OAKLEY STREET HOUSING SUPPORT CENTER

RFB-DCB-01-26

ADDENDUM # 2

Re: Questions and Answers; updated technical specifications; updated drawings

Sheet C-150 – Grading, Erosion and Sediment Control Plan

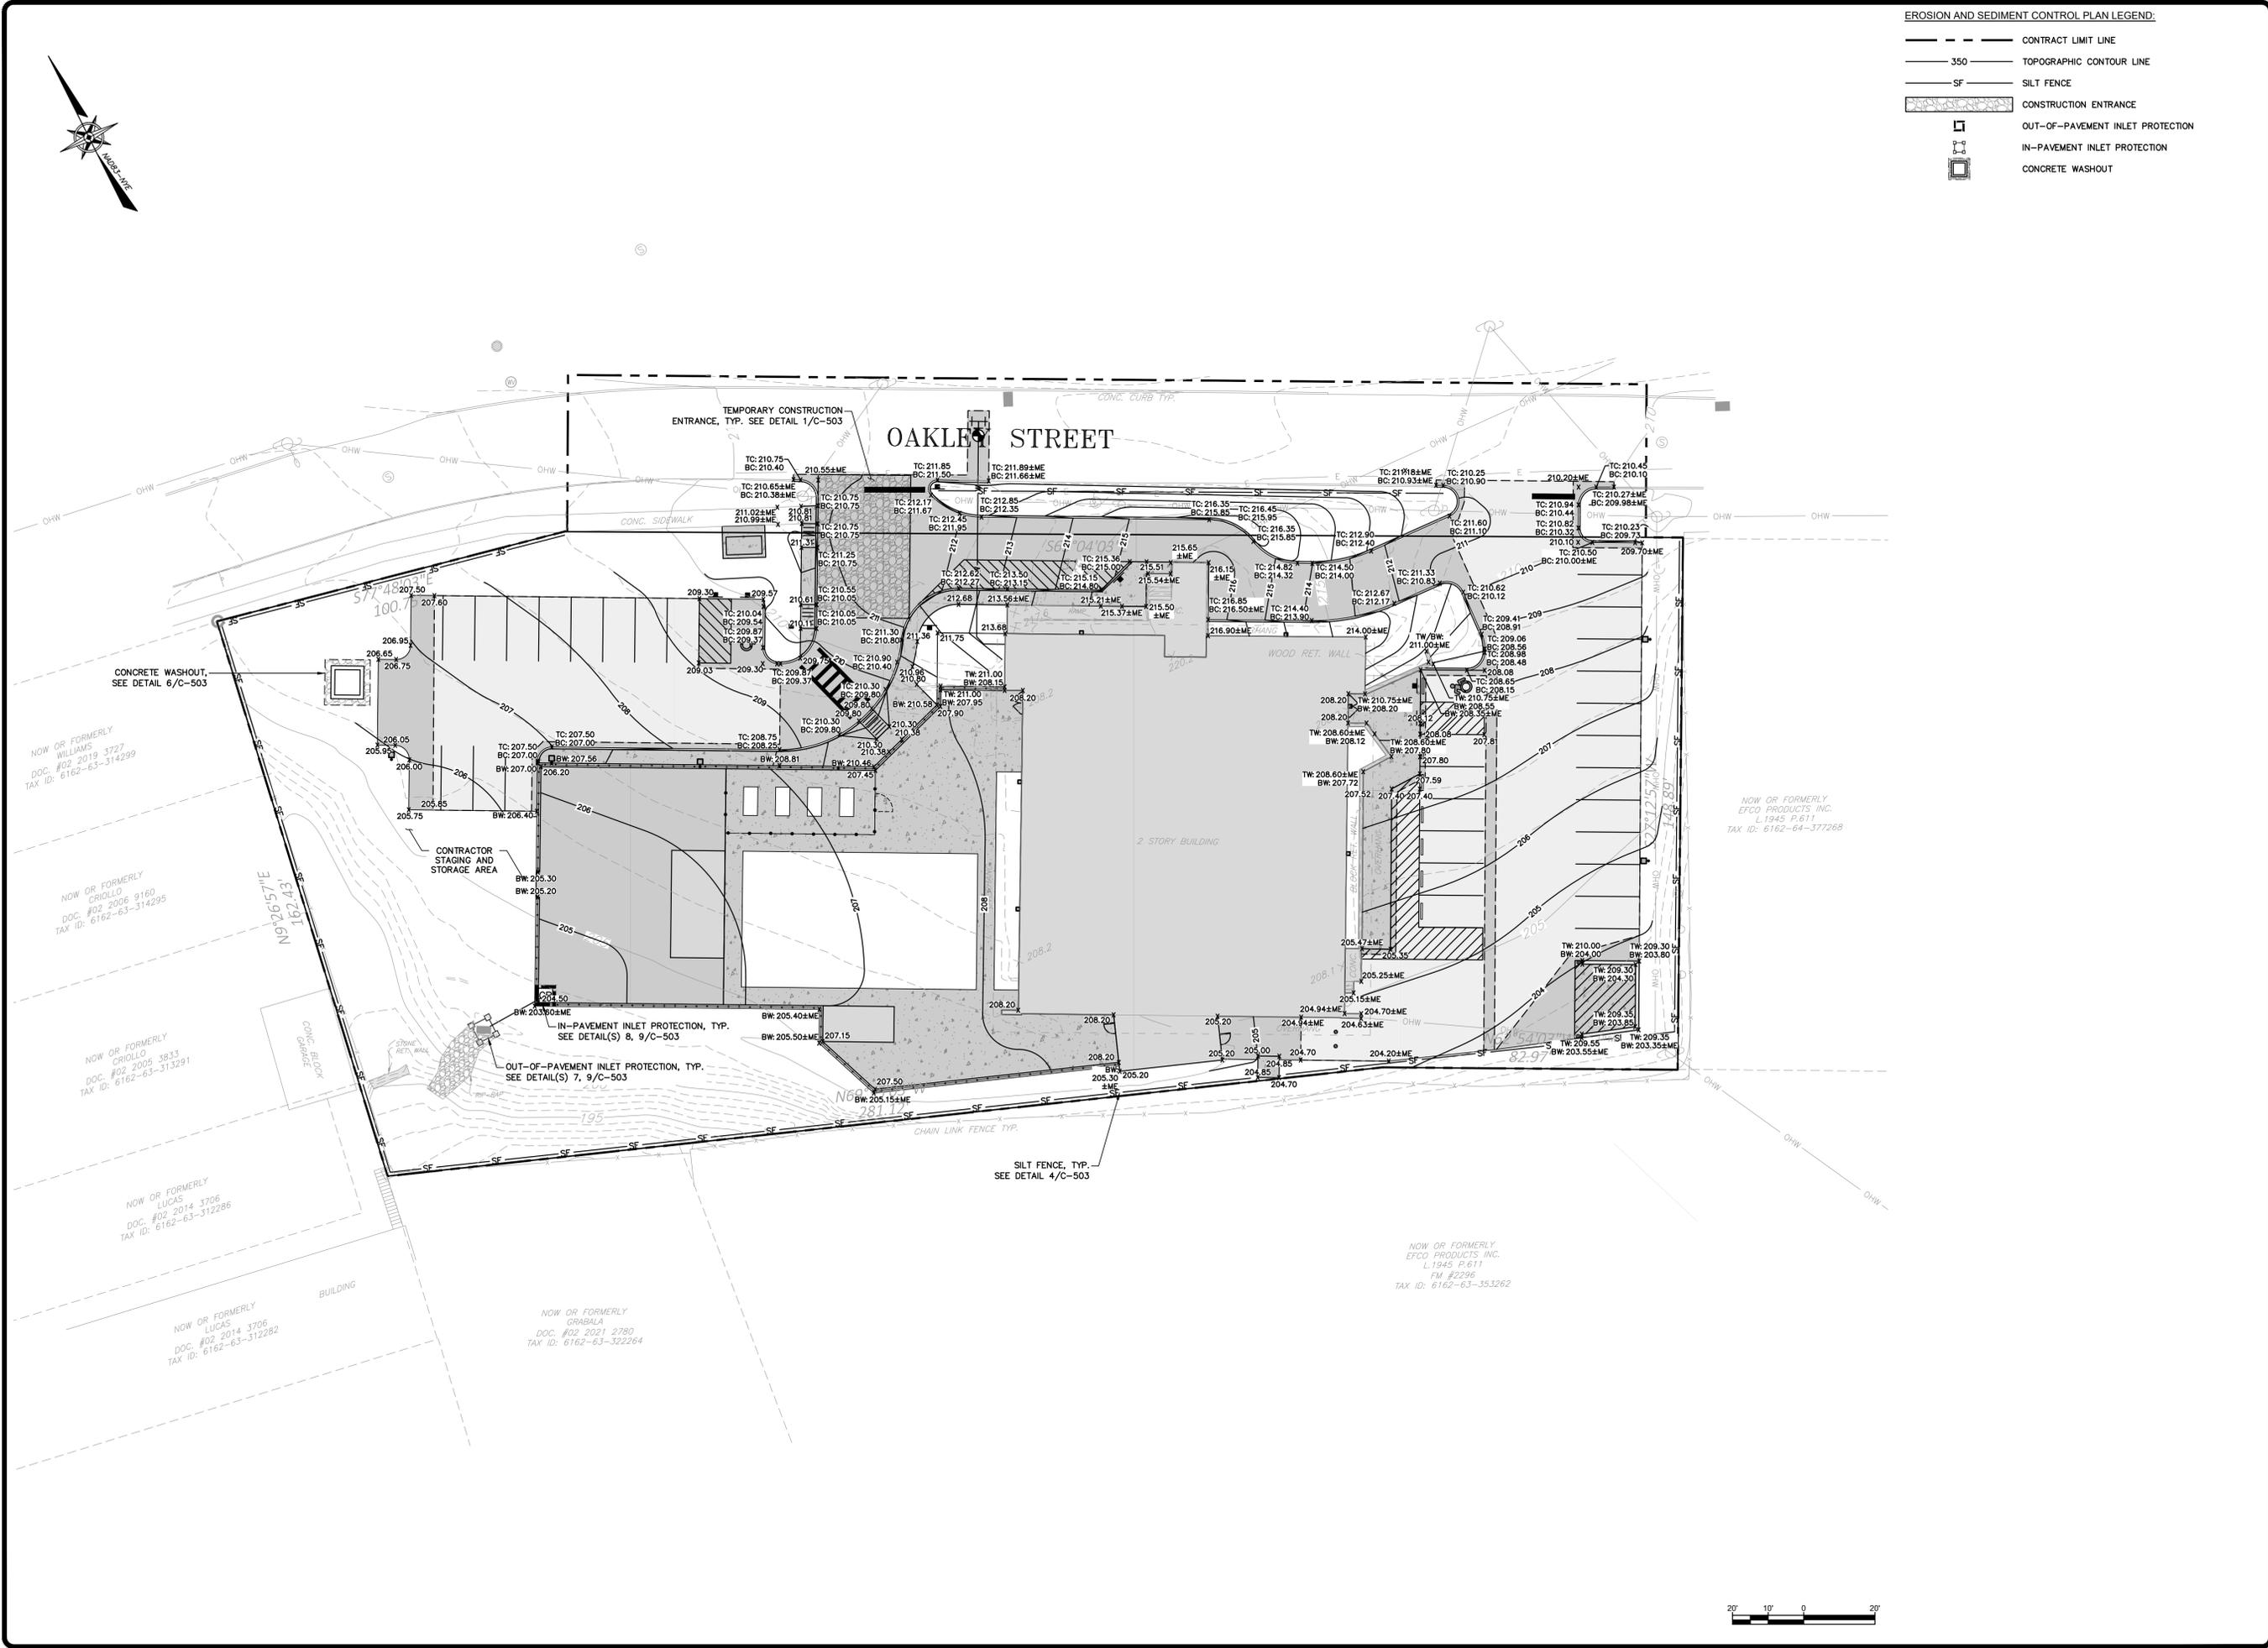
- A45: Shades to be inside mounted.**
- Q46: Drawing C-110 indicates milling of existing asphalt pavement at the East Parking Area, while Drawing C-150 indicates modifications to existing contours in the same general area. Please confirm the required pavement scope in the East Parking Area where contour revisions are shown on C-150:

The contour revisions shown on Sheet C-150 reflect minor surface corrections to address existing irregularities and ensure the asphalt surface is properly sloped to provide positive drainage.

1 PLUMBING: 1ST FLOOR CONSTRUCTION SANITARY PLAN
SCALE: 1/8"=1'-0"

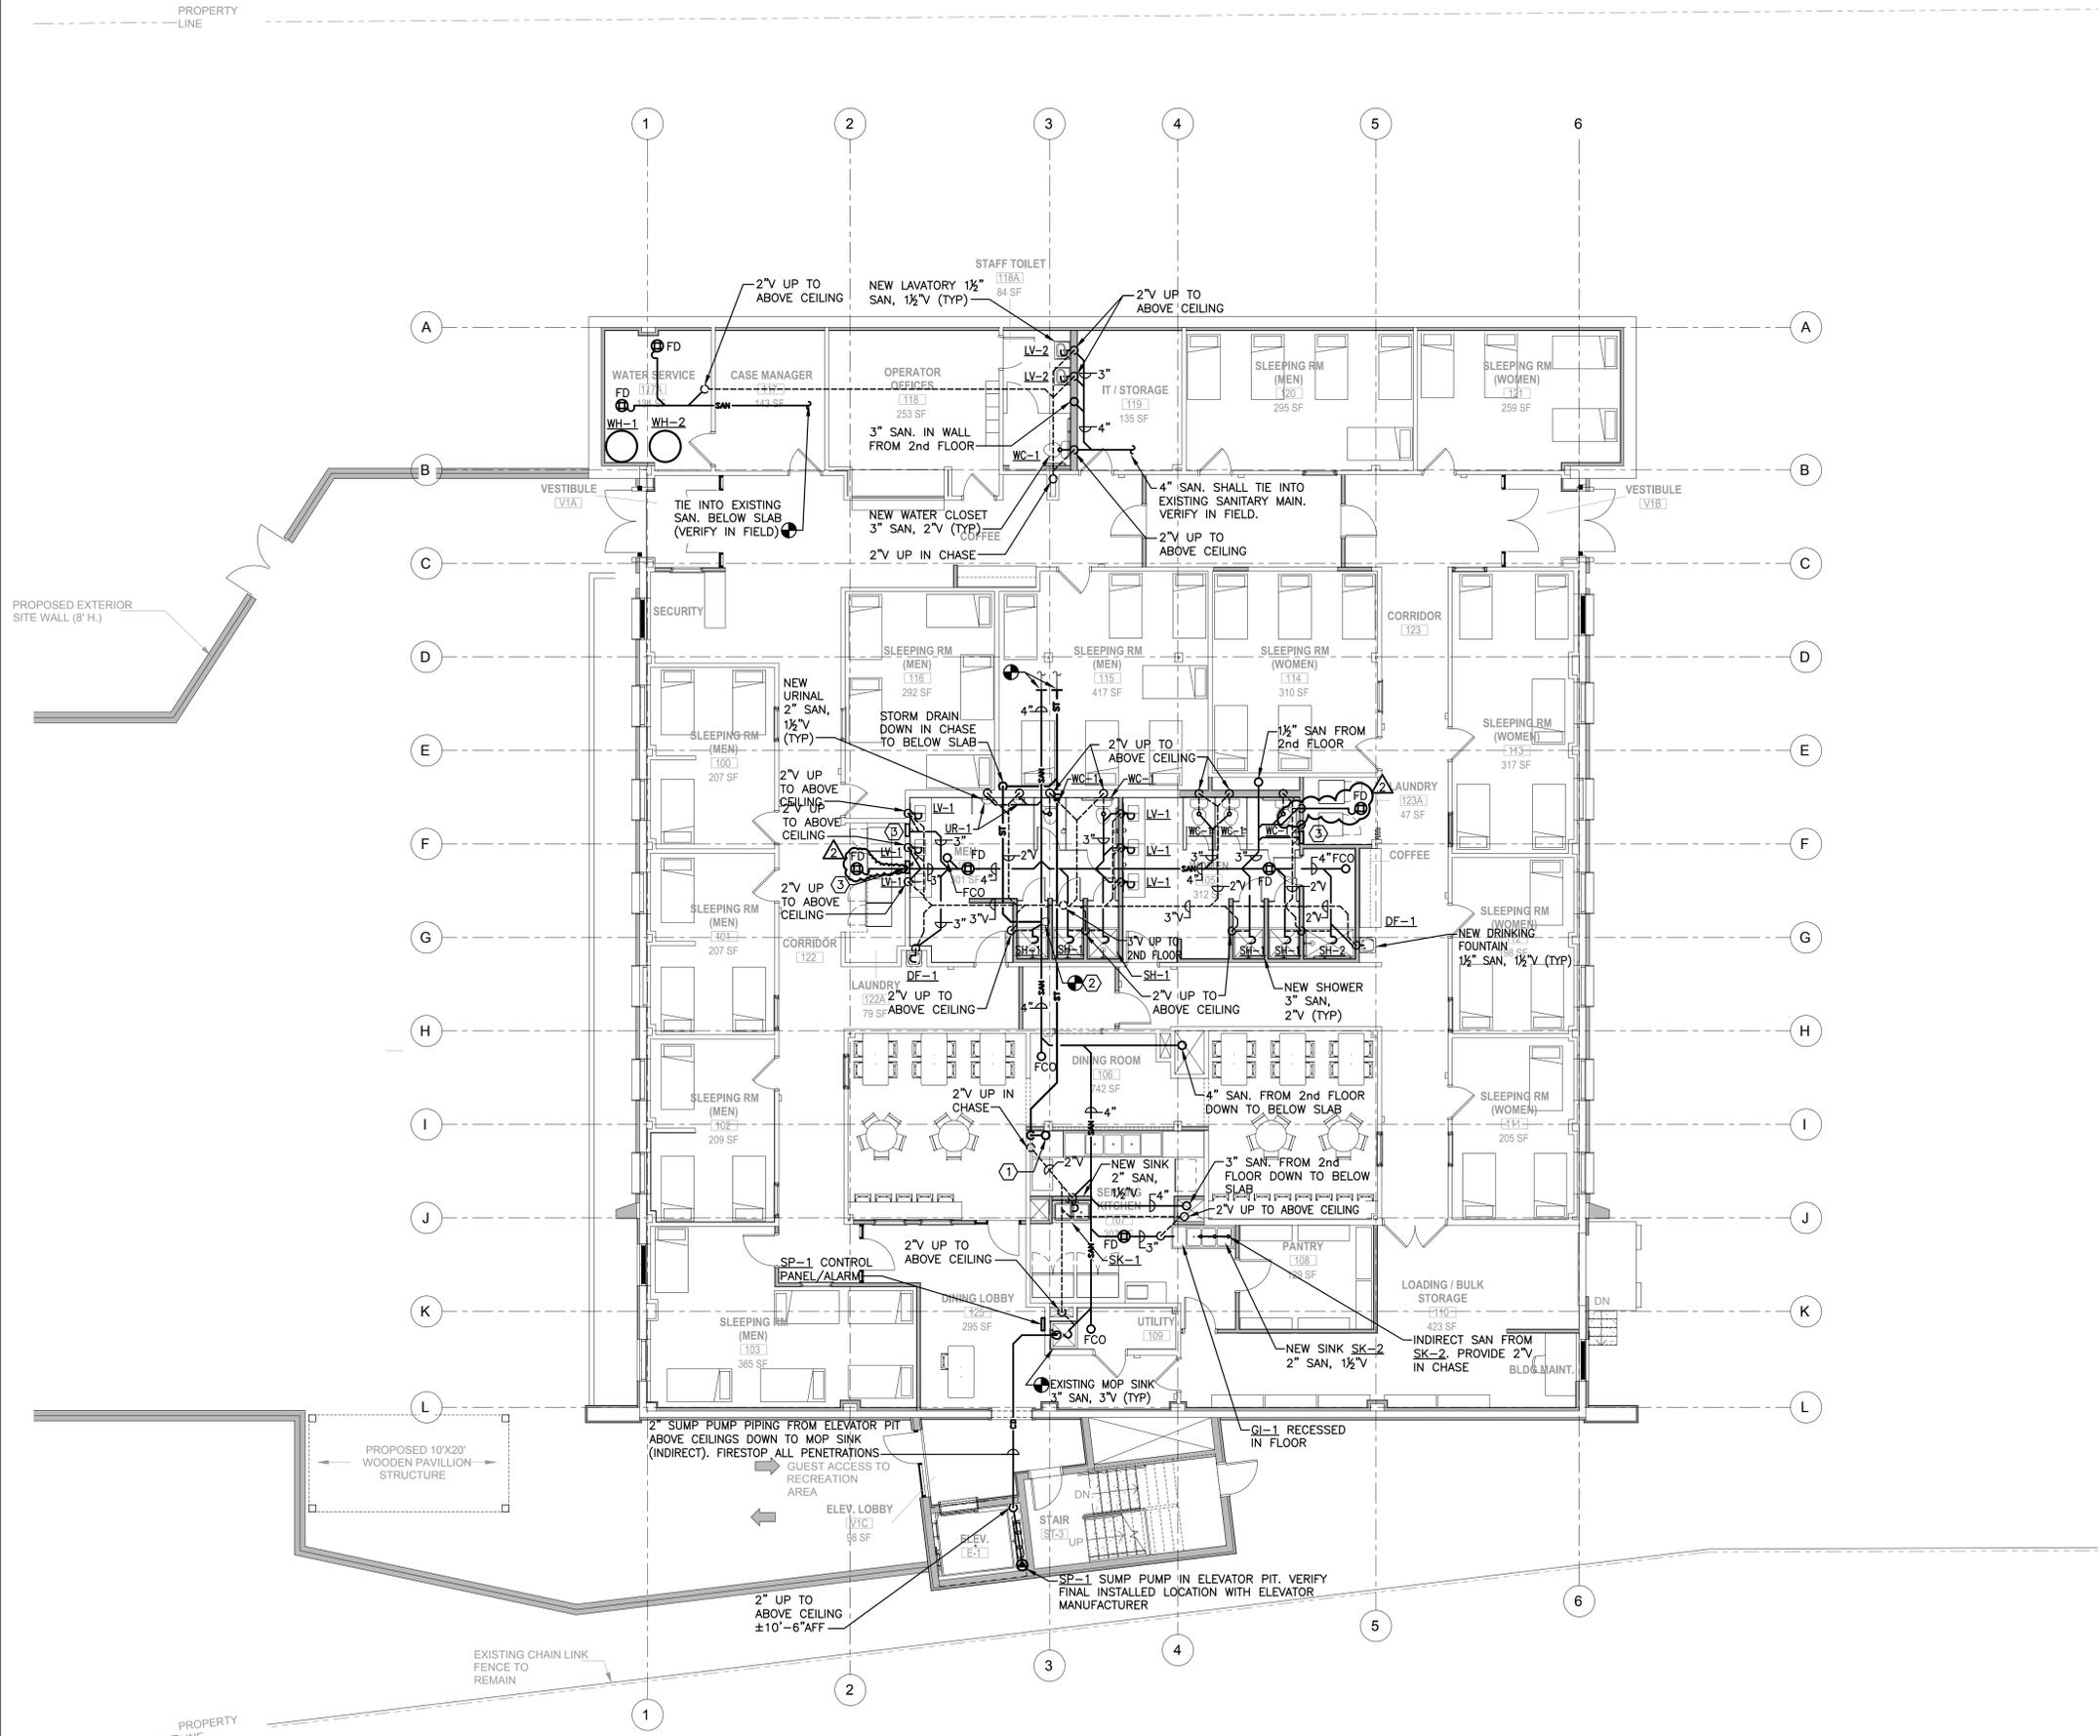
1. SHEET P-101 (SEE REVISED DRAWING):

- ADD (1) FLOOR DRAIN TO LAUNDRY 122A & ADD (1) FLOOR DRAIN TO LAUNDRY 123A.

1 PLUMBING: 2ND FLOOR CONSTRUCTION SANITARY PLAN
SCALE: 1/8"=1'-0"

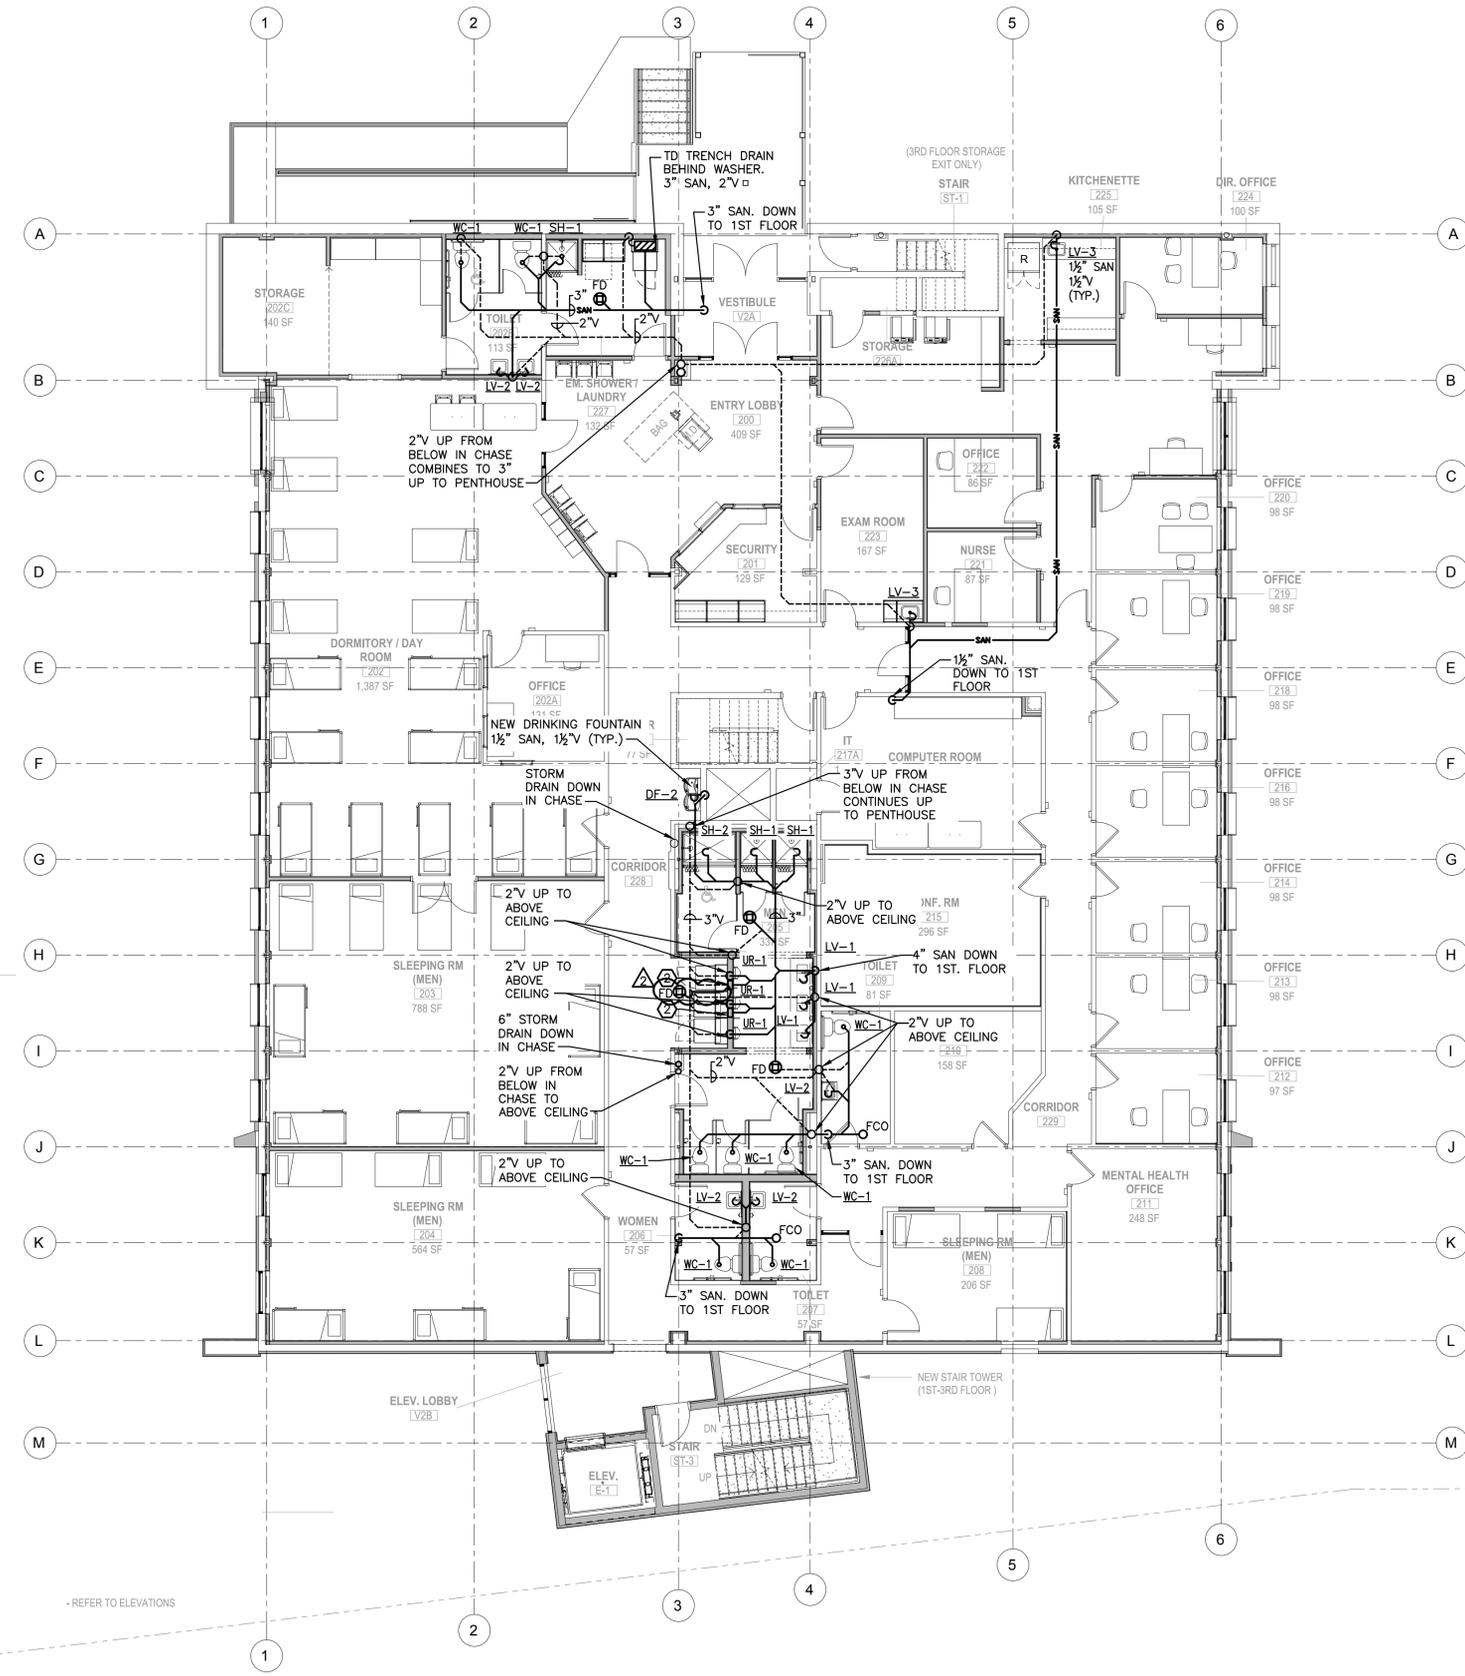
2. SHEET P-102 (SEE REVISED DRAWING):

- ADD (1) FLOOR DRAIN TO CORRIDOR IN FRONT OF CLOTHES WASHERS.
